RAPIER AVENUE SUBDIVISION

Engineering Comments: **FINAL PLAT COMMENTS** (should be addressed prior to submitting the FINAL PLAT for review and/or signature by the City Engineer):

This application was heldover from the January 6th meeting to give staff time to review the revised plat submitted after the report was completed for that meeting. The applicant also submitted proof of ownership of the subject property.

DETAIL SITE PLAN

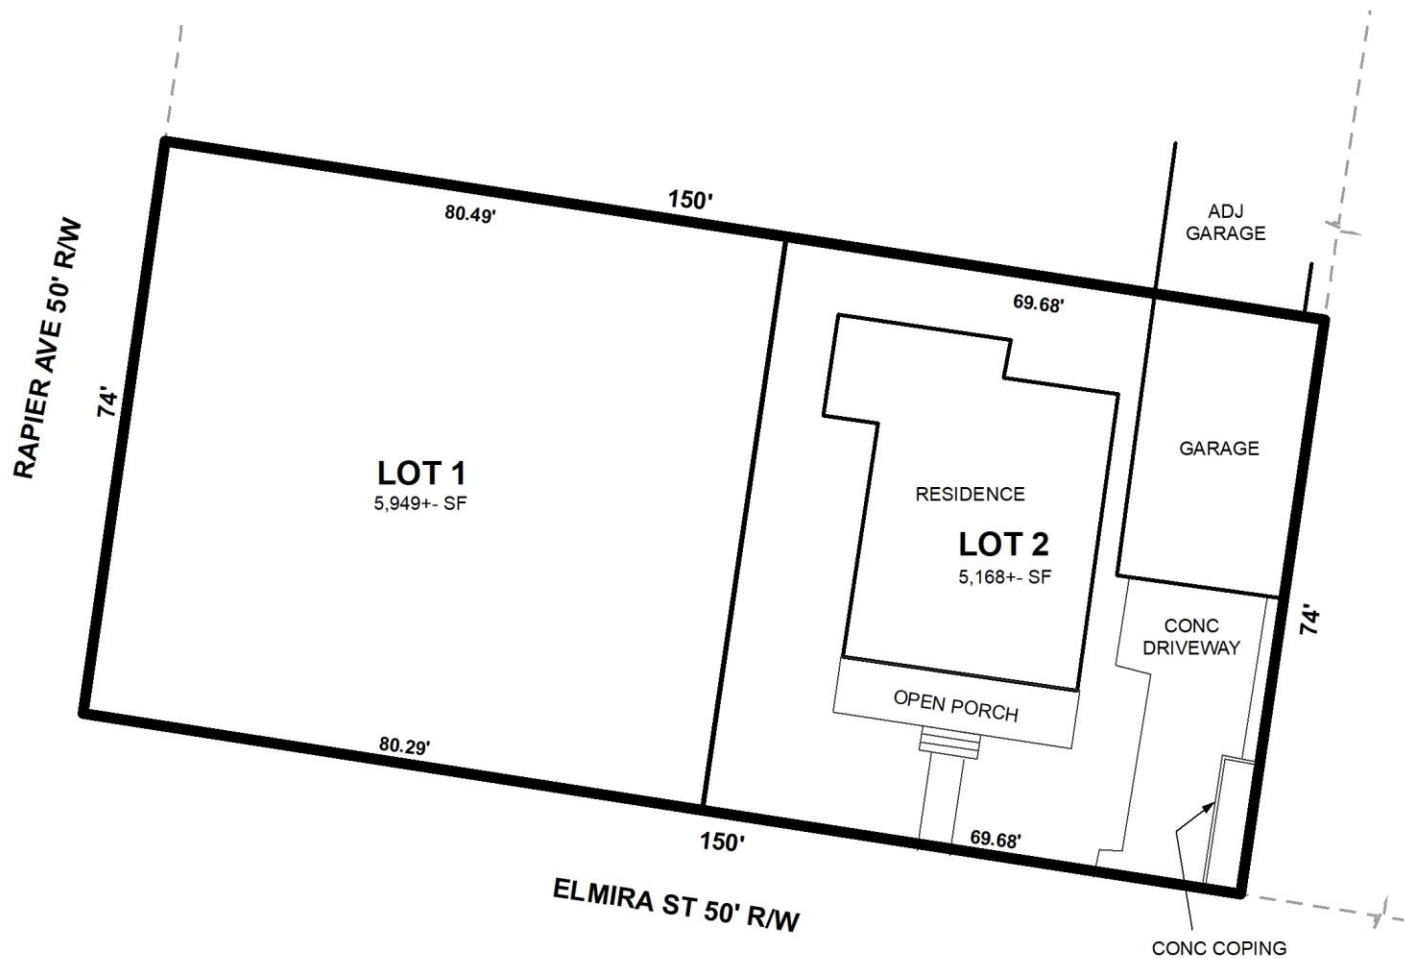
- B. Review and revise the last distance call-out on the south boundary of the proposed subdivision.
- C. Provide the Surveyor's and Owner's (notarized) signatures.

The revised plat indicates the proposed subdivision reduced to two lots. Lot 1 would have frontage on both Rapier Avenue and Elmira Street. Lot 2 would front only Elmira Street. Both streets are minor streets with curb and gutter and compliant 50-foot rights-of-way; therefore, no frontage dedication would be required. As on the preliminary plat, the right-of-way widths of both streets should be retained on the Final Plat, if approved. A 25-foot corner radius should be required at the intersection of Rapier Avenue and Elmira Street if determined necessary by the Engineering Department.

The proposed lots will not meet the minimum area requirements (7,200 square feet of area) of Section V.D.2. of the Subdivision Regulations. However, as the site is within an older part of the City where substandard size lots are common, and as the applicant complied with the Commission's requirement of reducing the subdivision to two lots, a waiver of Section V.D.2. would seem in order. Moreover, at 5,900 and 5,100 square feet per lot, this would seem in keeping with the surrounding area, as the lots at the Southwest corner range from 5,500 to 5,700 square feet. The lot size labels in both square feet and acres should be retained on the Final Plat, adjusted for any required radius dedication, or a table should be furnished on the Final Plat providing the same information.

No minimum building setback lines are indicated on the preliminary plat. Section V.D.9. of the Subdivision Regulations requires at least a minimum front building setback of 25 feet. Since the site is located within a historic district, relief from the normal building setbacks and site coverage limitation is automatically granted via the more flexible Historic District Overlay under Section 64-3.G. of the Zoning Ordinance. Therefore, it is recommended that Section V.D.9. of the Subdivision Regulations be waived, and that a note be placed on the Final Plat stating that all setbacks shall be determined by Section 64-3.G. Historic District Overlay requirements of the Zoning Ordinance. A note should also be required on the Final Plat stating that each lot is limited to 50% maximum site coverage.

Based upon the preceding, and with waivers of Sections V.D.2. and V.D.9., the plat meets the minimum requirements of the Subdivision Regulations and is recommended for Tentative Approval, subject to the following conditions:

- 1) retention of the right-of-way widths of Rapier Avenue and Elmira Street on the Final Plat;*
- 2) revision of the plat to provide a 25-foot corner radius at the intersection of Rapier Avenue and Elmira Street if determined necessary by the Engineering Department;*

- 3) retention of the lot size labels in both square feet and acres on the Final Plat, adjusted for any required radius dedication, or the furnishing of a table on the Final Plat providing the same information;

- 4) placement of a note on the Final Plat stating that all setbacks shall be determined by Section 64-3.G. Historic District Overlay requirements of the Zoning Ordinance;

- 5) placement of a note on the Final Plat stating that each lot is limited to 50% maximum site coverage;
- 6) compliance with the Engineering comments: (FINAL PLAT COMMENTS (should be addressed prior to submitting the FINAL PLAT for review and/or signature by the City Engineer: A. Provide all of the required information on the SUBDIVISION PLAT (i.e. signature blocks, signatures, certification statements, written legal description, required notes, legend, scale, bearings and distances) that is required by the current Alabama State Board of Licensure for Professional Engineers and Land Surveyors. B. Review and revise the last distance call-out on the south boundary of the proposed subdivision. C. Provide the Surveyor's and Owner's (notarized) signatures. D. Email a pdf copy of the FINAL SUBDIVISION PLAT and LETTER OF DECISION to the Permitting Engineering Dept. for review at land.disturbance@cityofmobile.org prior to obtaining any signatures. No signatures are required on the drawing. E. After addressing all of the FINAL SUBDIVISION PLAT review comments provide the ORIGINAL (with all signatures except for the Planning Commission, Traffic Engineering, and City Engineer), one (1) copy, and a transmittal letter to the Engineering Permitting Department. They can be dropped off at 205 Government St. or mailed to PO Box 1827, Mobile, AL, 36633.);
